Request for Advice

Application No. **SSD-93020230**
Property Address **40-48 Redan Street, Mosman**

Extract depicting a 1m setback to the western Redan Lane boundary (Source: Drawing 2102, FJC Studio)

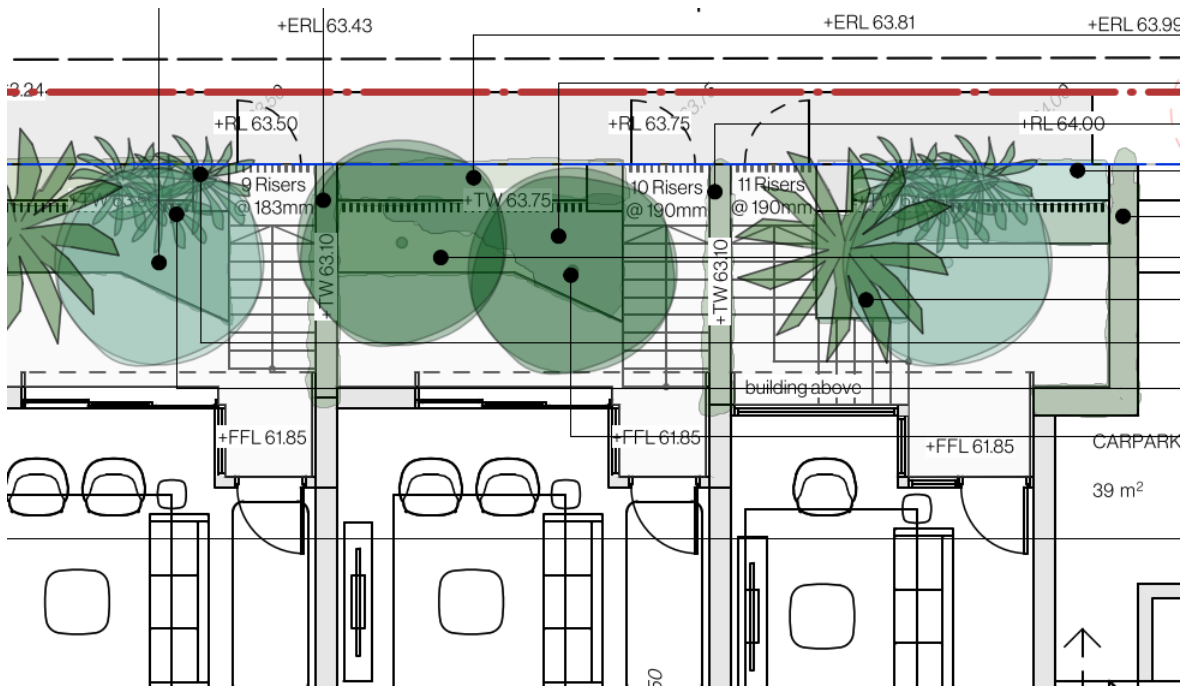
<p>Council recommends increased basement level setbacks to the Redan Street and Redan Lane property boundaries to facilitate public domain improvements which include native canopy tree planting and increased levels of indigenous planting that is endemic to Mosman.</p>
<p>17</p>	<p>Insufficient Information and Discrepancies in Application Documents</p> <p>Due to insufficient information, a complete and accurate assessment cannot be carried out. It is requested that the following additional information be submitted:</p> <ul style="list-style-type: none"> (a) Walking Distance Survey (b) Accessibility Compliance Report (c) Building Code of Australia (BCA) Compliance Report (d) Engineering drawings, details, certification and reports (refer to Items 10, 12 and 13 for details) <p>The application documents also include discrepancies in relation to proposed works and the proposal's numerical data across the drawings and documents. These include, but are not limited to the following:</p> <ul style="list-style-type: none"> • Inconsistency between levels (RLs) shown on architectural plans, elevations and sections (e.g., top of lift overrun shown as RL 92.250 on roof plan, however shown as RL 93.900 on section and elevation drawings. • Inconsistency with the proposed GFA of the development. This is documented as follows: <ul style="list-style-type: none"> ○ 9,214.8sqm (Architectural GFA Diagrams, noting that Council does not agree with the methodology of calculations, refer to Item 3 for details) ○ 9,305.3sqm (Clause 4.6 – Building Height) ○ 9,246sqm (Clause 4.6 – Wall Height) ○ 9,215sqm (EIS) • Inconsistency with the proposed affordable housing GFA. This is documented as follows: <ul style="list-style-type: none"> ○ 1,353.9sqm (Architectural GFA Diagrams) ○ 1,447.1sqm (Clause 4.6 – Building Height) ○ 1,387sqm (Clause 4.6 – Wall Height) ○ 1,387sqm (EIS) • Inconsistency with the proposed landscaped area of the development. This is documented as follows: <ul style="list-style-type: none"> ○ 1,104.1sqm or 34.1% (Architectural Landscaped Area Diagrams, noting that Council does not agree with the methodology of calculations, refer to Item 8 for details) ○ 1,153.1sqm or 35.7% (EIS) • Inconsistency with the proposed deep soil zone area of the development. This is documented as follows:
